Contract #: 04-0120F4Cty: SF/ALA Rte: 80 PM: 13.2/13.9File #: 69.25B**QUALITY ASSURANCE -- NON-CONFORMANCE REPORT****Location:** Changxing Island, Shanghai, P.R. China**Report No:** NCR-000870**Prime Contractor:** American Bridge/Fluor Enterprises, a JV**Date:** 19-Oct-2010**Submitting Contractor:** Zhenhua Port Machinery Company, Ltd (ZPMC), Changxing Island**NCR #:** ZPMC-0832**Type of problem:**

**NON-CONFORMANCE REPORT TRANSMITTAL**

**Dear:** Mr. Charles Kanapicki  
**Attention:** Mr. Thomas Nilsson Project/Fabrication Manager  
**Subject:** NCR No. ZPMC-0832

## NCR PROPOSED RESOLUTION

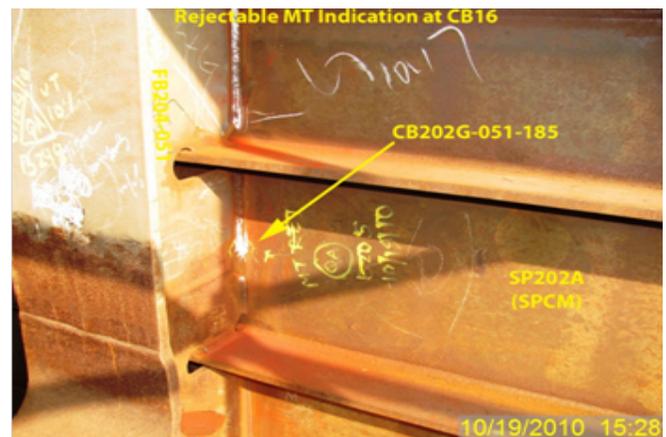
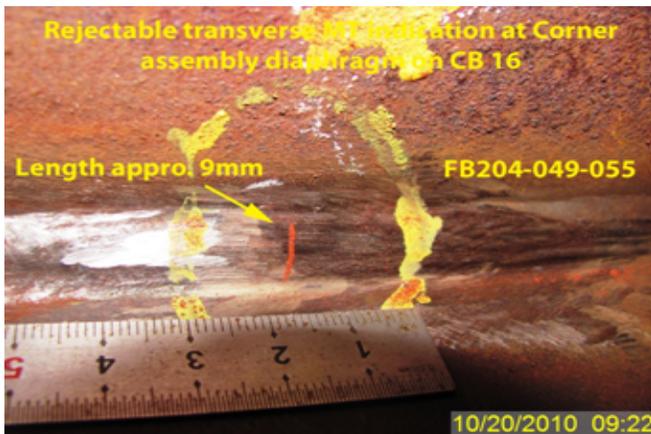
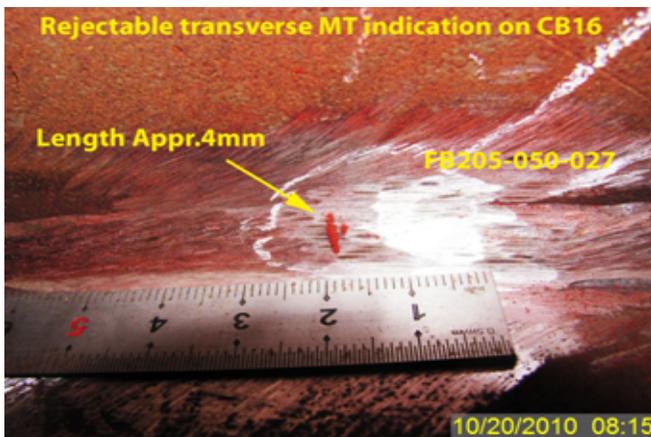
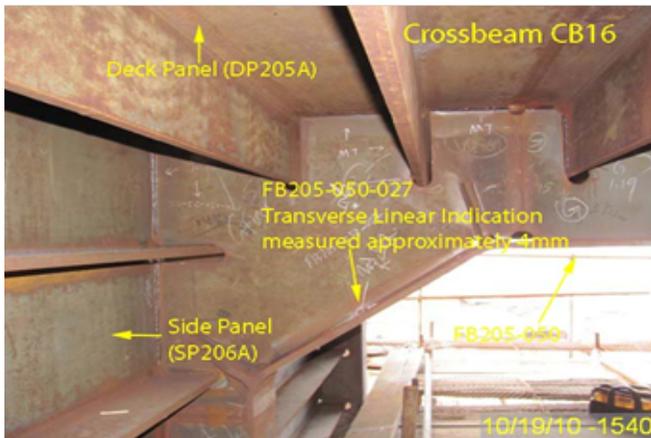
- One Transverse Linear crack measuring approximately 4mm.
- The weld is identified as FB205-050-027.
- The weld is a fillet weld joining floor beam diaphragm web plate to flange.
- Y location is approximately 550mm from west side panel identified as SP206A.

- One Transverse Linear crack measuring approximately 9mm.
- The weld is identified as FB204-049-55.
- The weld is the fillet weld joining flange to floor beam diaphragm web plate.
- Y location is approximately 250mm from east side cope hole.
- Three (3) Longitudinal Linear cracks in welds identified as CB202G-051-180, CB202G-051-185 & CB202G-049-185.
- Weld CB202G-051-180.
- Longitudinal Linear indication measures approximately 6mm.
- Y location is 0mm from the Side panel (SP205A).
- Weld CB202G-051-180 is a Fillet Weld joining Floor Beam Intermediate Diaphragm FB205-051 to Side Panel SP205A.
- SP205A is designated as SPCM.

- Weld CB202G-051-185.
- Longitudinal Linear indication measuring approximately 4mm.
- Y location is 0mm from the Side panel (SP202A)
- Weld CB202G-051-185 is a Fillet Weld joining Floor Beam Intermediate Diaphragm FB204-051 to Side

-Weld CB202G-049-185 is a Fillet Weld joining Floor Beam Intermediate Diaphragm FB204-049 to Side Panel SP202A.

-Weld FB205-050-027 is within an area previously tested and accepted by ZPMC Quality Control (QC) personnel. ZPMC's QC personnel are required to perform 10% MT of this weld.

-Welds CB202G-051-180, CB202G-051-185 & CB202G-049-185 are within an area previously tested and accepted by ZPMC Quality Control (QC) personnel. ZPMC's QC personnel are required to perform 100% MT inspection of these welds.

AWS D1.5 (02) Table 6.8 specifies fusion type discontinuities greater than 1.6mm in length shall be rejected on 6mm fillet welds.

AWS D1.5 (02) Section 6.26.2 "Welds that are subject to MT in addition to visual inspection shall have no cracks."

**Reference Resolution:** ZPMC has repaired the indications noted in the NCR and is providing NDT documentation after the repair to show the indications has been removed

The proposed resolution is acceptable. This NCR is closed.

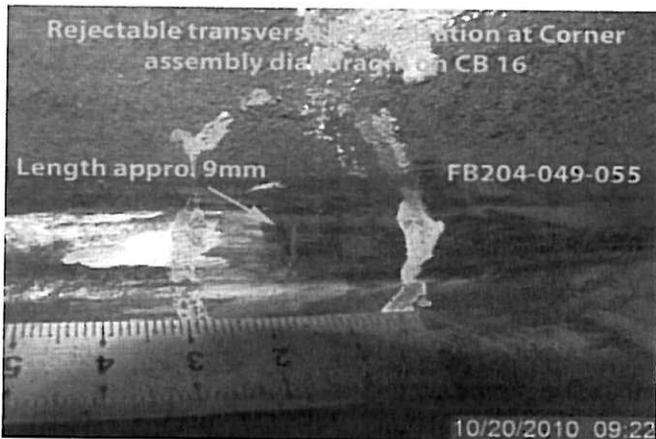
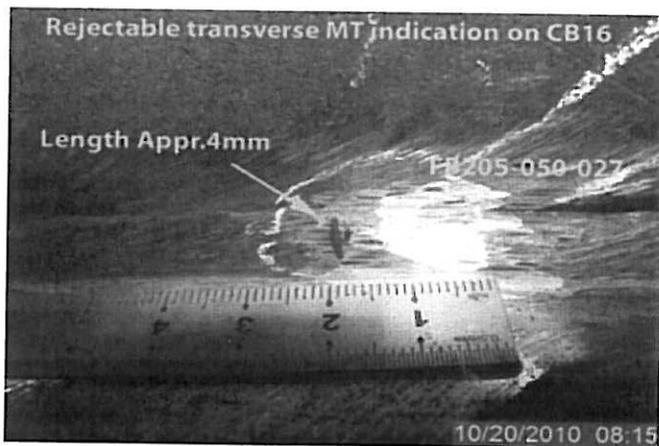
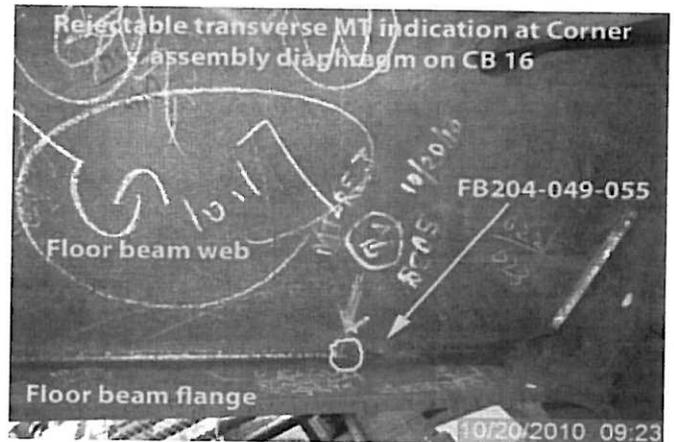
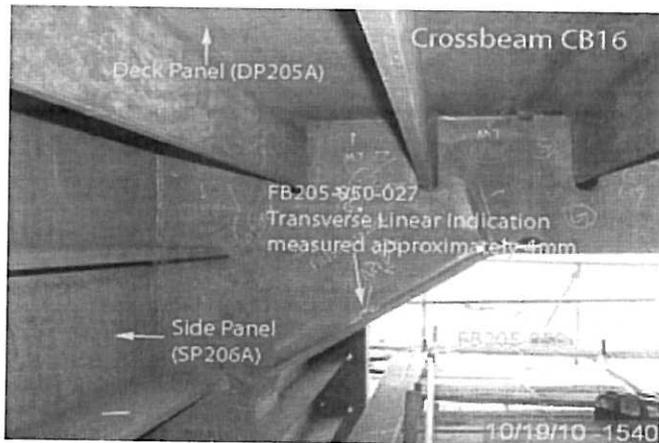
- One Transverse Linear crack measuring approximately 4mm.
- The weld is identified as FB205-050-027.
- The weld is a fillet weld joining floor beam diaphragm web plate to flange.

- Y location is approximately 550mm from west side panel identified as SP206A.
- One Transverse Linear crack measuring approximately 9mm.
- The weld is identified as FB204-049-55.

- The weld is the fillet weld joining flange to floor beam diaphragm web plate.
- Y location is approximately 250mm from east side cope hole.
- Three (3) Longitudinal Linear cracks in welds identified as CB202G-051-180, CB202G-051-185 & CB202G-049-185.

- Weld CB202G-051-180.
- Longitudinal Linear indication measures approximately 6mm.
- Y location is 0mm from the Side panel (SP205A).
- Weld CB202G-051-180 is a Fillet Weld joining Floor Beam Intermediate Diaphragm FB205-051 to Side Panel SP205A.

-Weld CB202G-049-185 is a Fillet Weld joining Floor Beam Intermediate Diaphragm FB204-049 to Side Panel SP202A.

-Weld FB205-050-027 is within an area previously tested and accepted by ZPMC Quality Control (QC) personnel. ZPMC's QC personnel are required to perform 10% MT of this weld.

-Welds CB202G-051-180, CB202G-051-185 & CB202G-049-185 are within an area previously tested and accepted by ZPMC Quality Control (QC) personnel. ZPMC's QC personnel are required to perform 100% MT inspection of these welds.

AWS D1.5 (02) Table 6.8 specifies fusion type discontinuities greater than 1.6mm in length shall be rejected on 6mm fillet welds.

AWS D1.5 (02) Section 6.26.2 "Welds that are subject to MT in addition to visual inspection shall have no cracks."
